PLANNING COMMISSION AGENDA

Tuesday, June 06, 2017
Breckenridge Council Chambers
150 Ski Hill Road

PLANNING COMMISSION MEETING

Planning Commission Staff Report

PL1.0
OVERALL
PLAZA PLAN

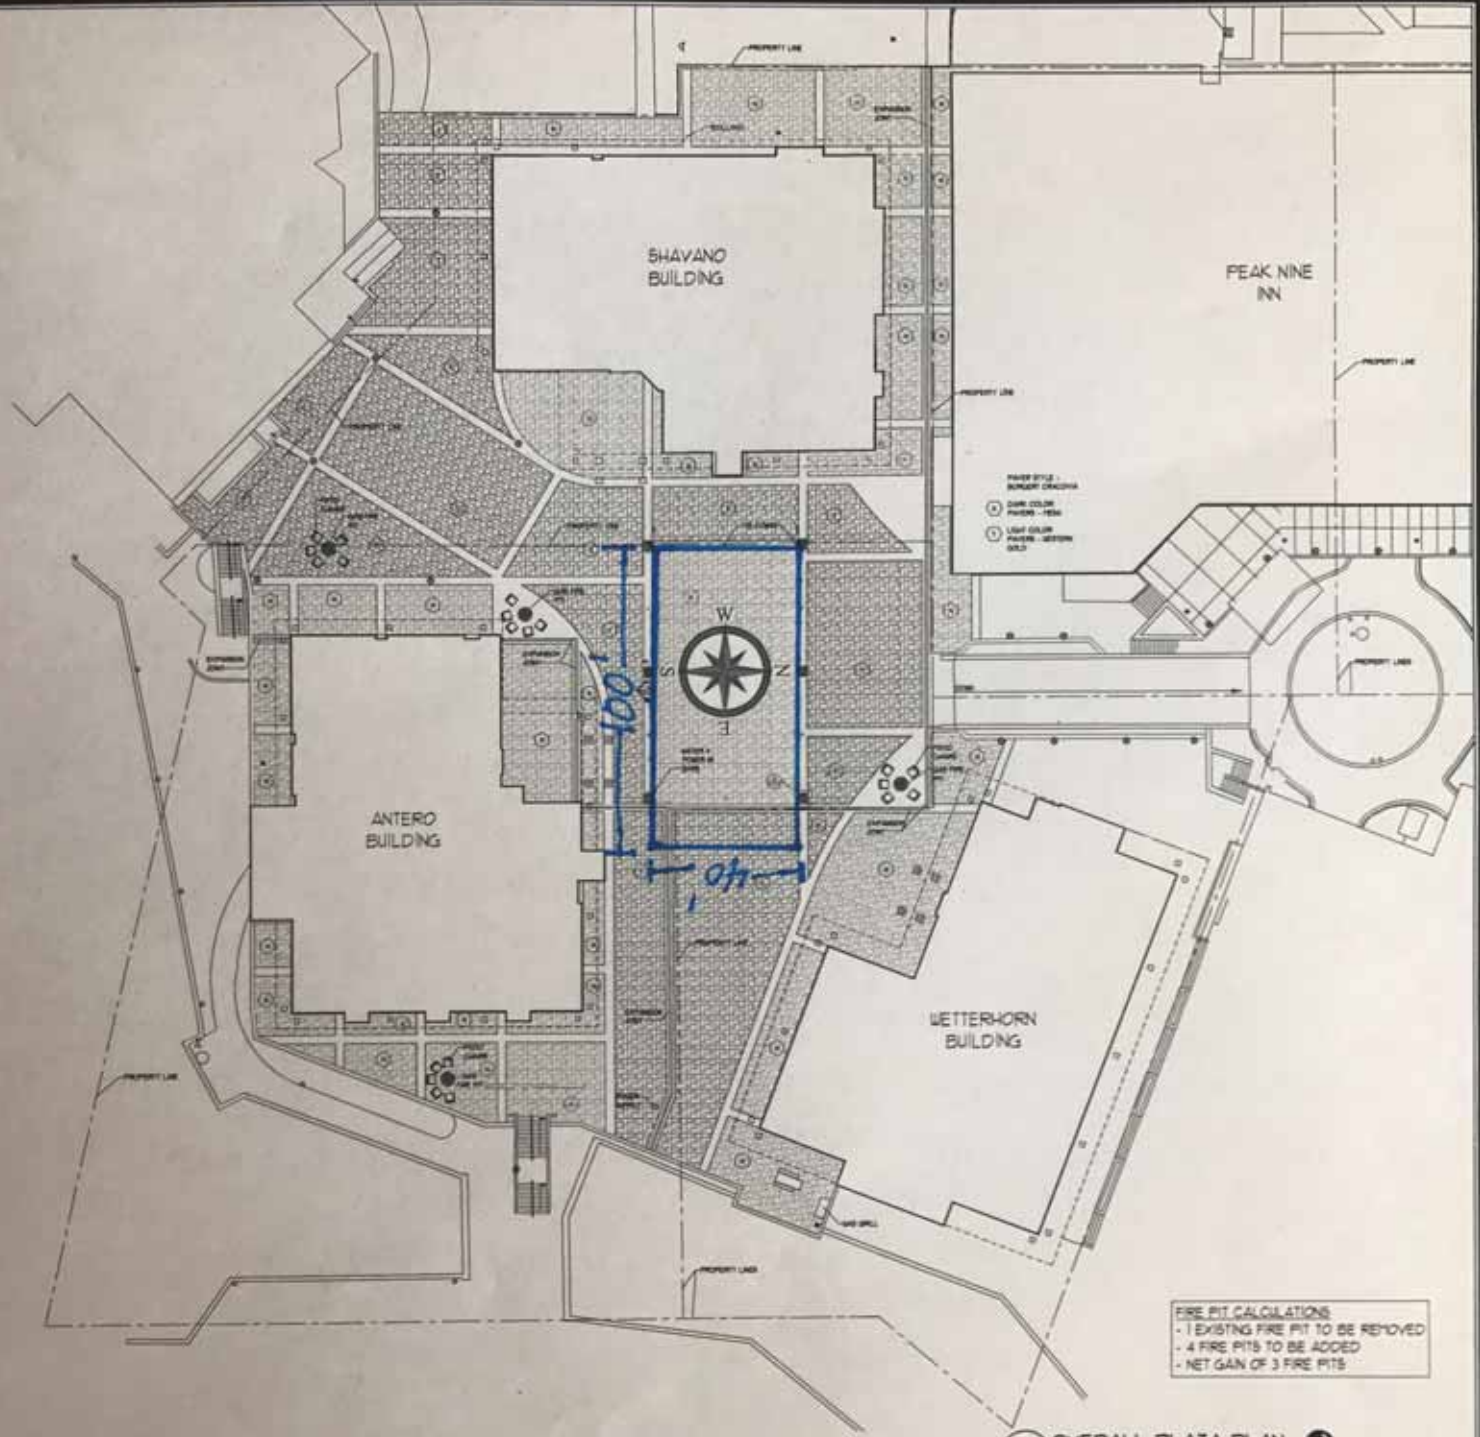
The tent is proposed to be placed in the center of the Village at Breckenridge Plaza, located mostly within the southern half of the 55.5' radius Utility and Access Easement, and is oriented lengthwise east to west. The plaza is devoid of required landscaping and is not used for parking. Staff has superimposed the submitted site plan with a recent survey of the property, showing the proposed location of the tent in relation to the surrounding buildings and the Easement. Staff finds that there is sufficient area remaining for effective pedestrian circulation, considering the tent will be erected during a less busy time of the year than ski season. The application has been referred to the Red, White and Blue Fire Department, who also requires a Tent Permit to ensure life-safety concerns and emergency service access and structural requirements are met prior to the tent being erected. Staff does not have any concerns.

SHEET TITLE: SITE PLAN
A101

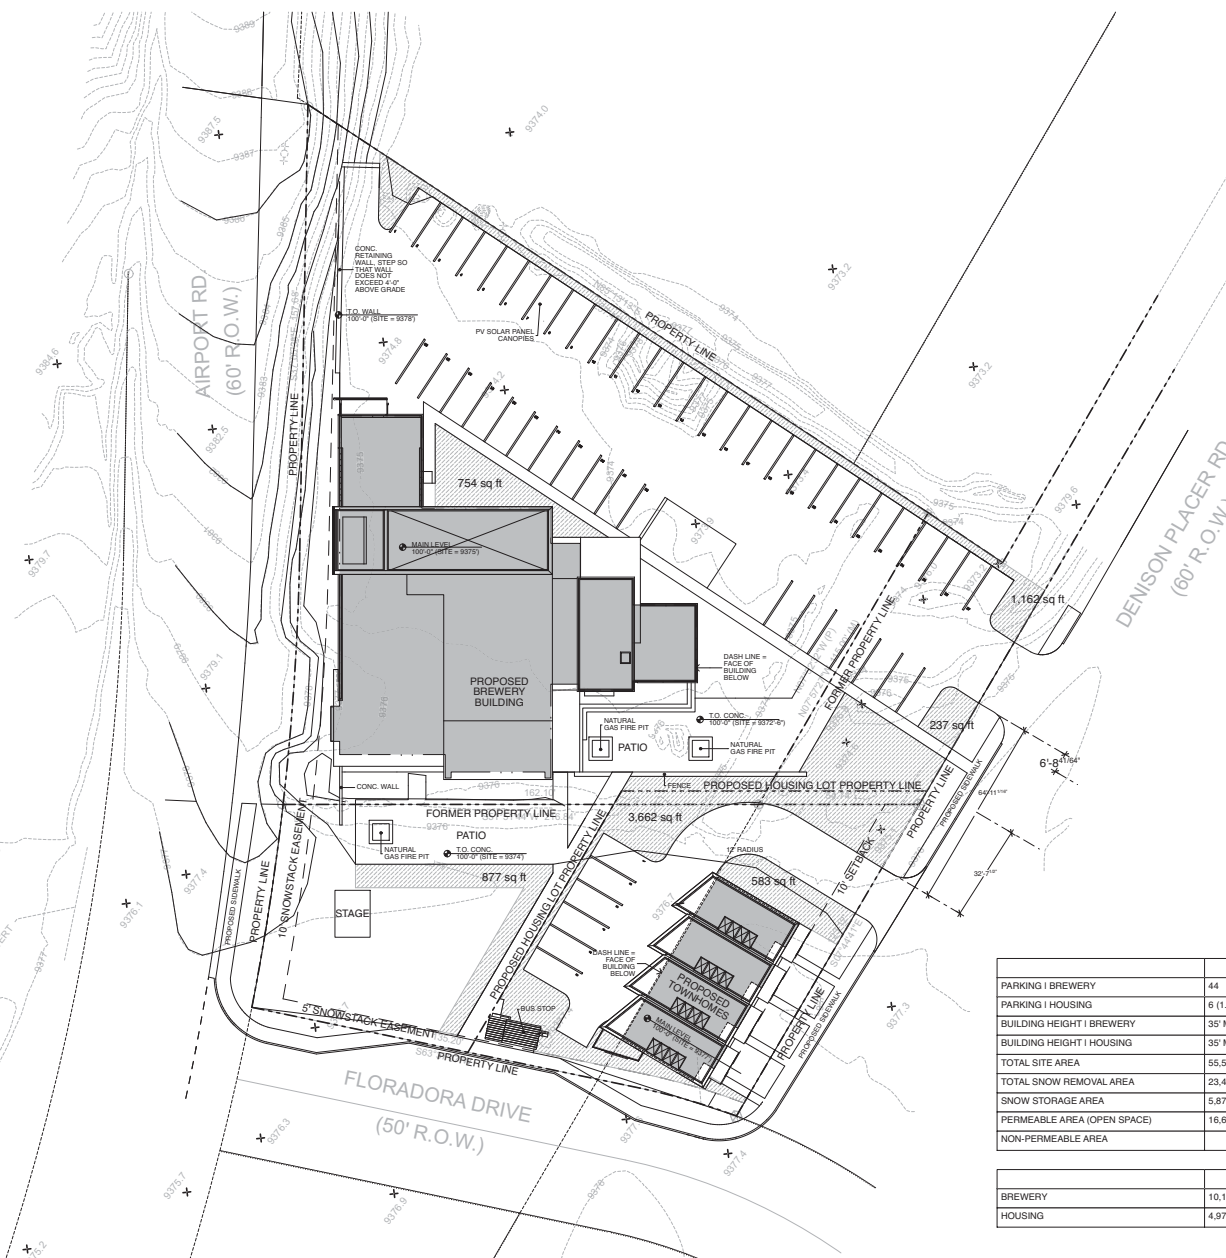
However, staff finds the areas proposed for snow storage are not functional. Generally, snow should be able to be stacked within 10 feet of the hardscape from which it is being cleared. The site plan proposes areas for snow storage that are up to 17 feet away from the hardscape being cleared, and require a significant amount transporting of snow to the designated snow stacking areas to make required square footage work.

Staff recommends that the Planning Commission assess negative four (-4) points for non-functional snow storage. Does the Commission agree?
